PLANNING & ZONING AGENDA ITEM #5

SUBJECT: Approval of a Rezoning request by amending the Planned Development for Williams Pointe Plat 9 including modification of the underlying zoning district of C-1A [Neighborhood Commercial District]/R-3 [Rental Multi-Family Residential District] to C-4[Office Park Commercial District]

RE: Williams Pointe Plat 9 PD Amendment & Williams Pointe 7 Rezoning (Access Systems)
Submittal #2

RE: Williams Pointe Plat 9 PD Amendment & Williams Pointe 7 Rezoning: Access Systems

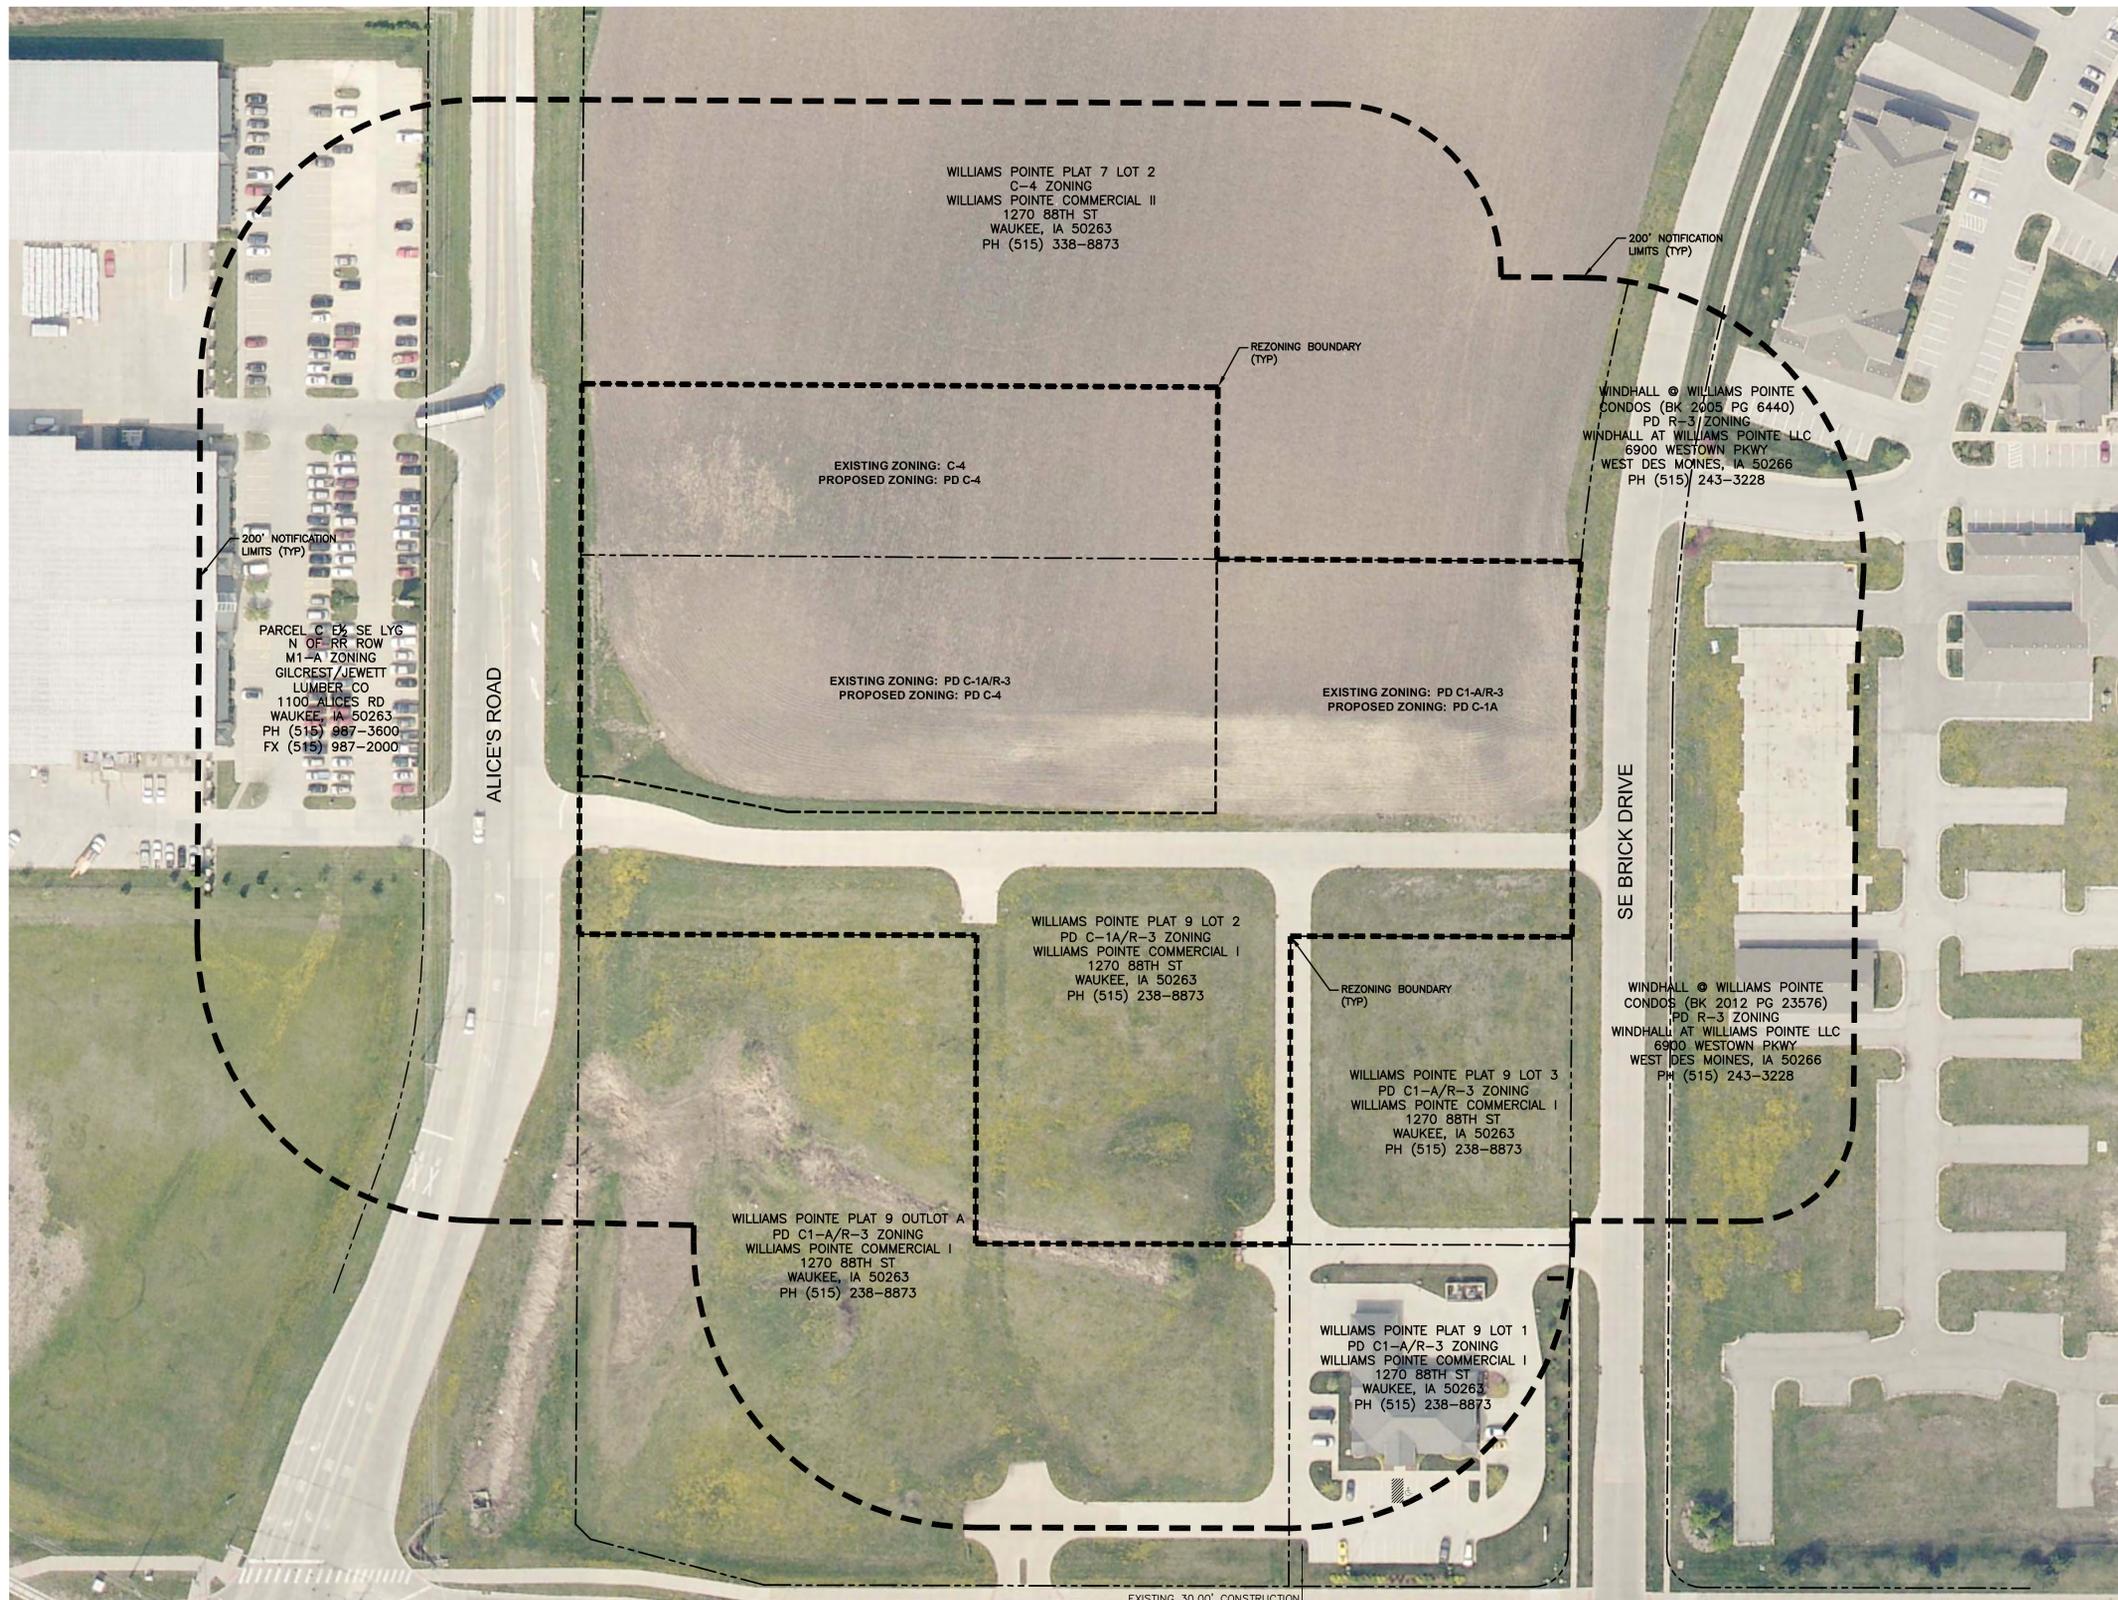
2. The rezoning map should be revised to include the entire parcel(s) planned to be used by Access Systems, but should also include the entire portion of Lot 2 Williams Pointe Plat 9 with the 200 foot buffer extending out from that area.

3. The ownership and consent information should be adjusted to address Comment #2 above. Additionally, the legal description should be adjusted to include the entirety of Lot 2 Williams Plat 9 in lieu of the portion currently referenced.

4. The existing zoning indicated on the rezoning map should be revised to PD C-1A/R-3 and C-4.

5. The proposed zoning indicated on the rezoning map should be revised to PD C-4 and PD C-1A.

6. The conceptual layout of the Access Systems site should be eliminated from the rezoning map.

The Rezoning Map has been revised accordingly.

The ownership, consent information, and legal description have been revised accordingly.

The existing zoning designations have been revised.

The proposed zoning designations have been revised.

The Access Systems site layout has been removed from the drawing.

ACCESS SYSTEMS
CONCEPTUAL DEVELOPMENT PLAN

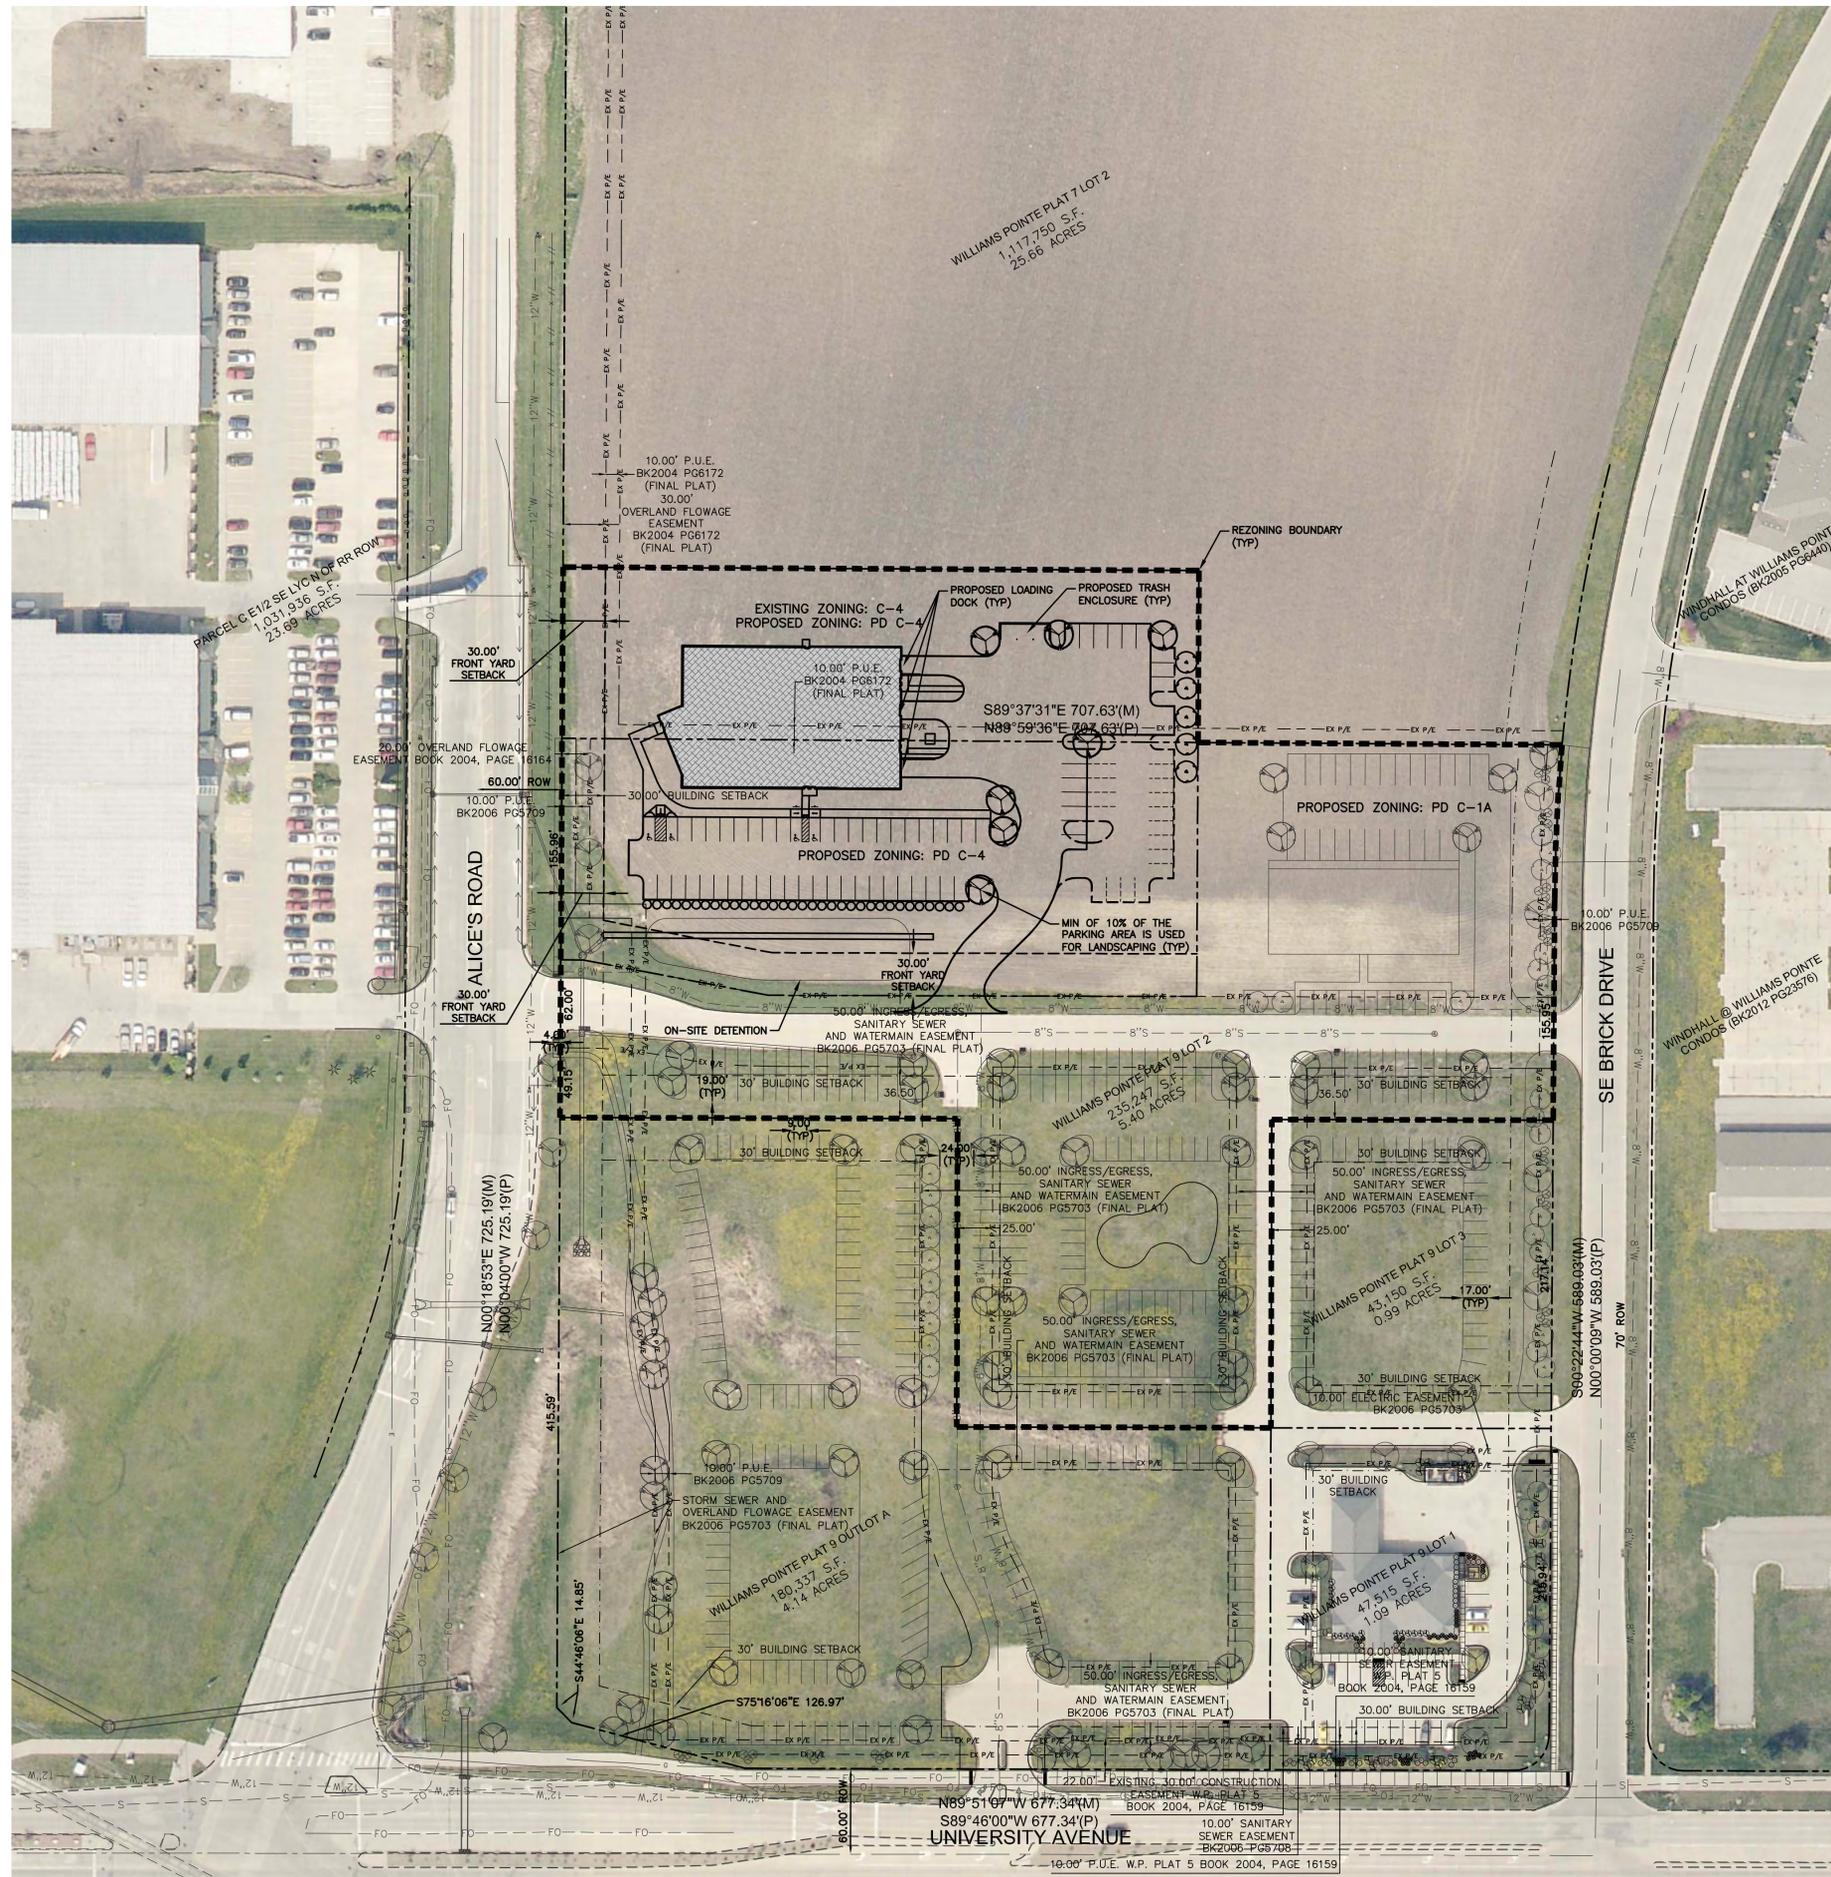
7. The plat and lot numbers for the areas in Plat 9 should be revised to reflect the recorded lot numbers or outlot designation from the final plat for Williams Pointe Plat 9 in lieu of the preliminary plat lot numbers previously used by the PD document for the various areas. Additionally, the easements should be indicated with recorded Book and Page.

8. The existing and proposed zoning designations should be revised as noted in the Rezoning Map Comments above.

9. The concept plan should be revised to identify any potential on-site detention contemplated on the Access Systems site.

10. Staff would request that the access drive into the Access Systems site be revised to align with the existing stub and planned southerly extension of the nearest access drive just to the west of the current location. Please address.

11. Staff would request that a conceptual landscaping plan be provided for the Access Systems site as the other planned lots in the concept plan identify landscaping. Please address.

The lot numbers have been revised accordingly. Book and Page numbers have been added to the easement call-outs.

Existing and proposed zoning designations have been revised.

The on-site detention for Access Systems has been added.

The access drive into the Access Systems site has been revised to align its centerline with that of the existing southern stub.

Conceptual landscape design for Access Systems has been added.
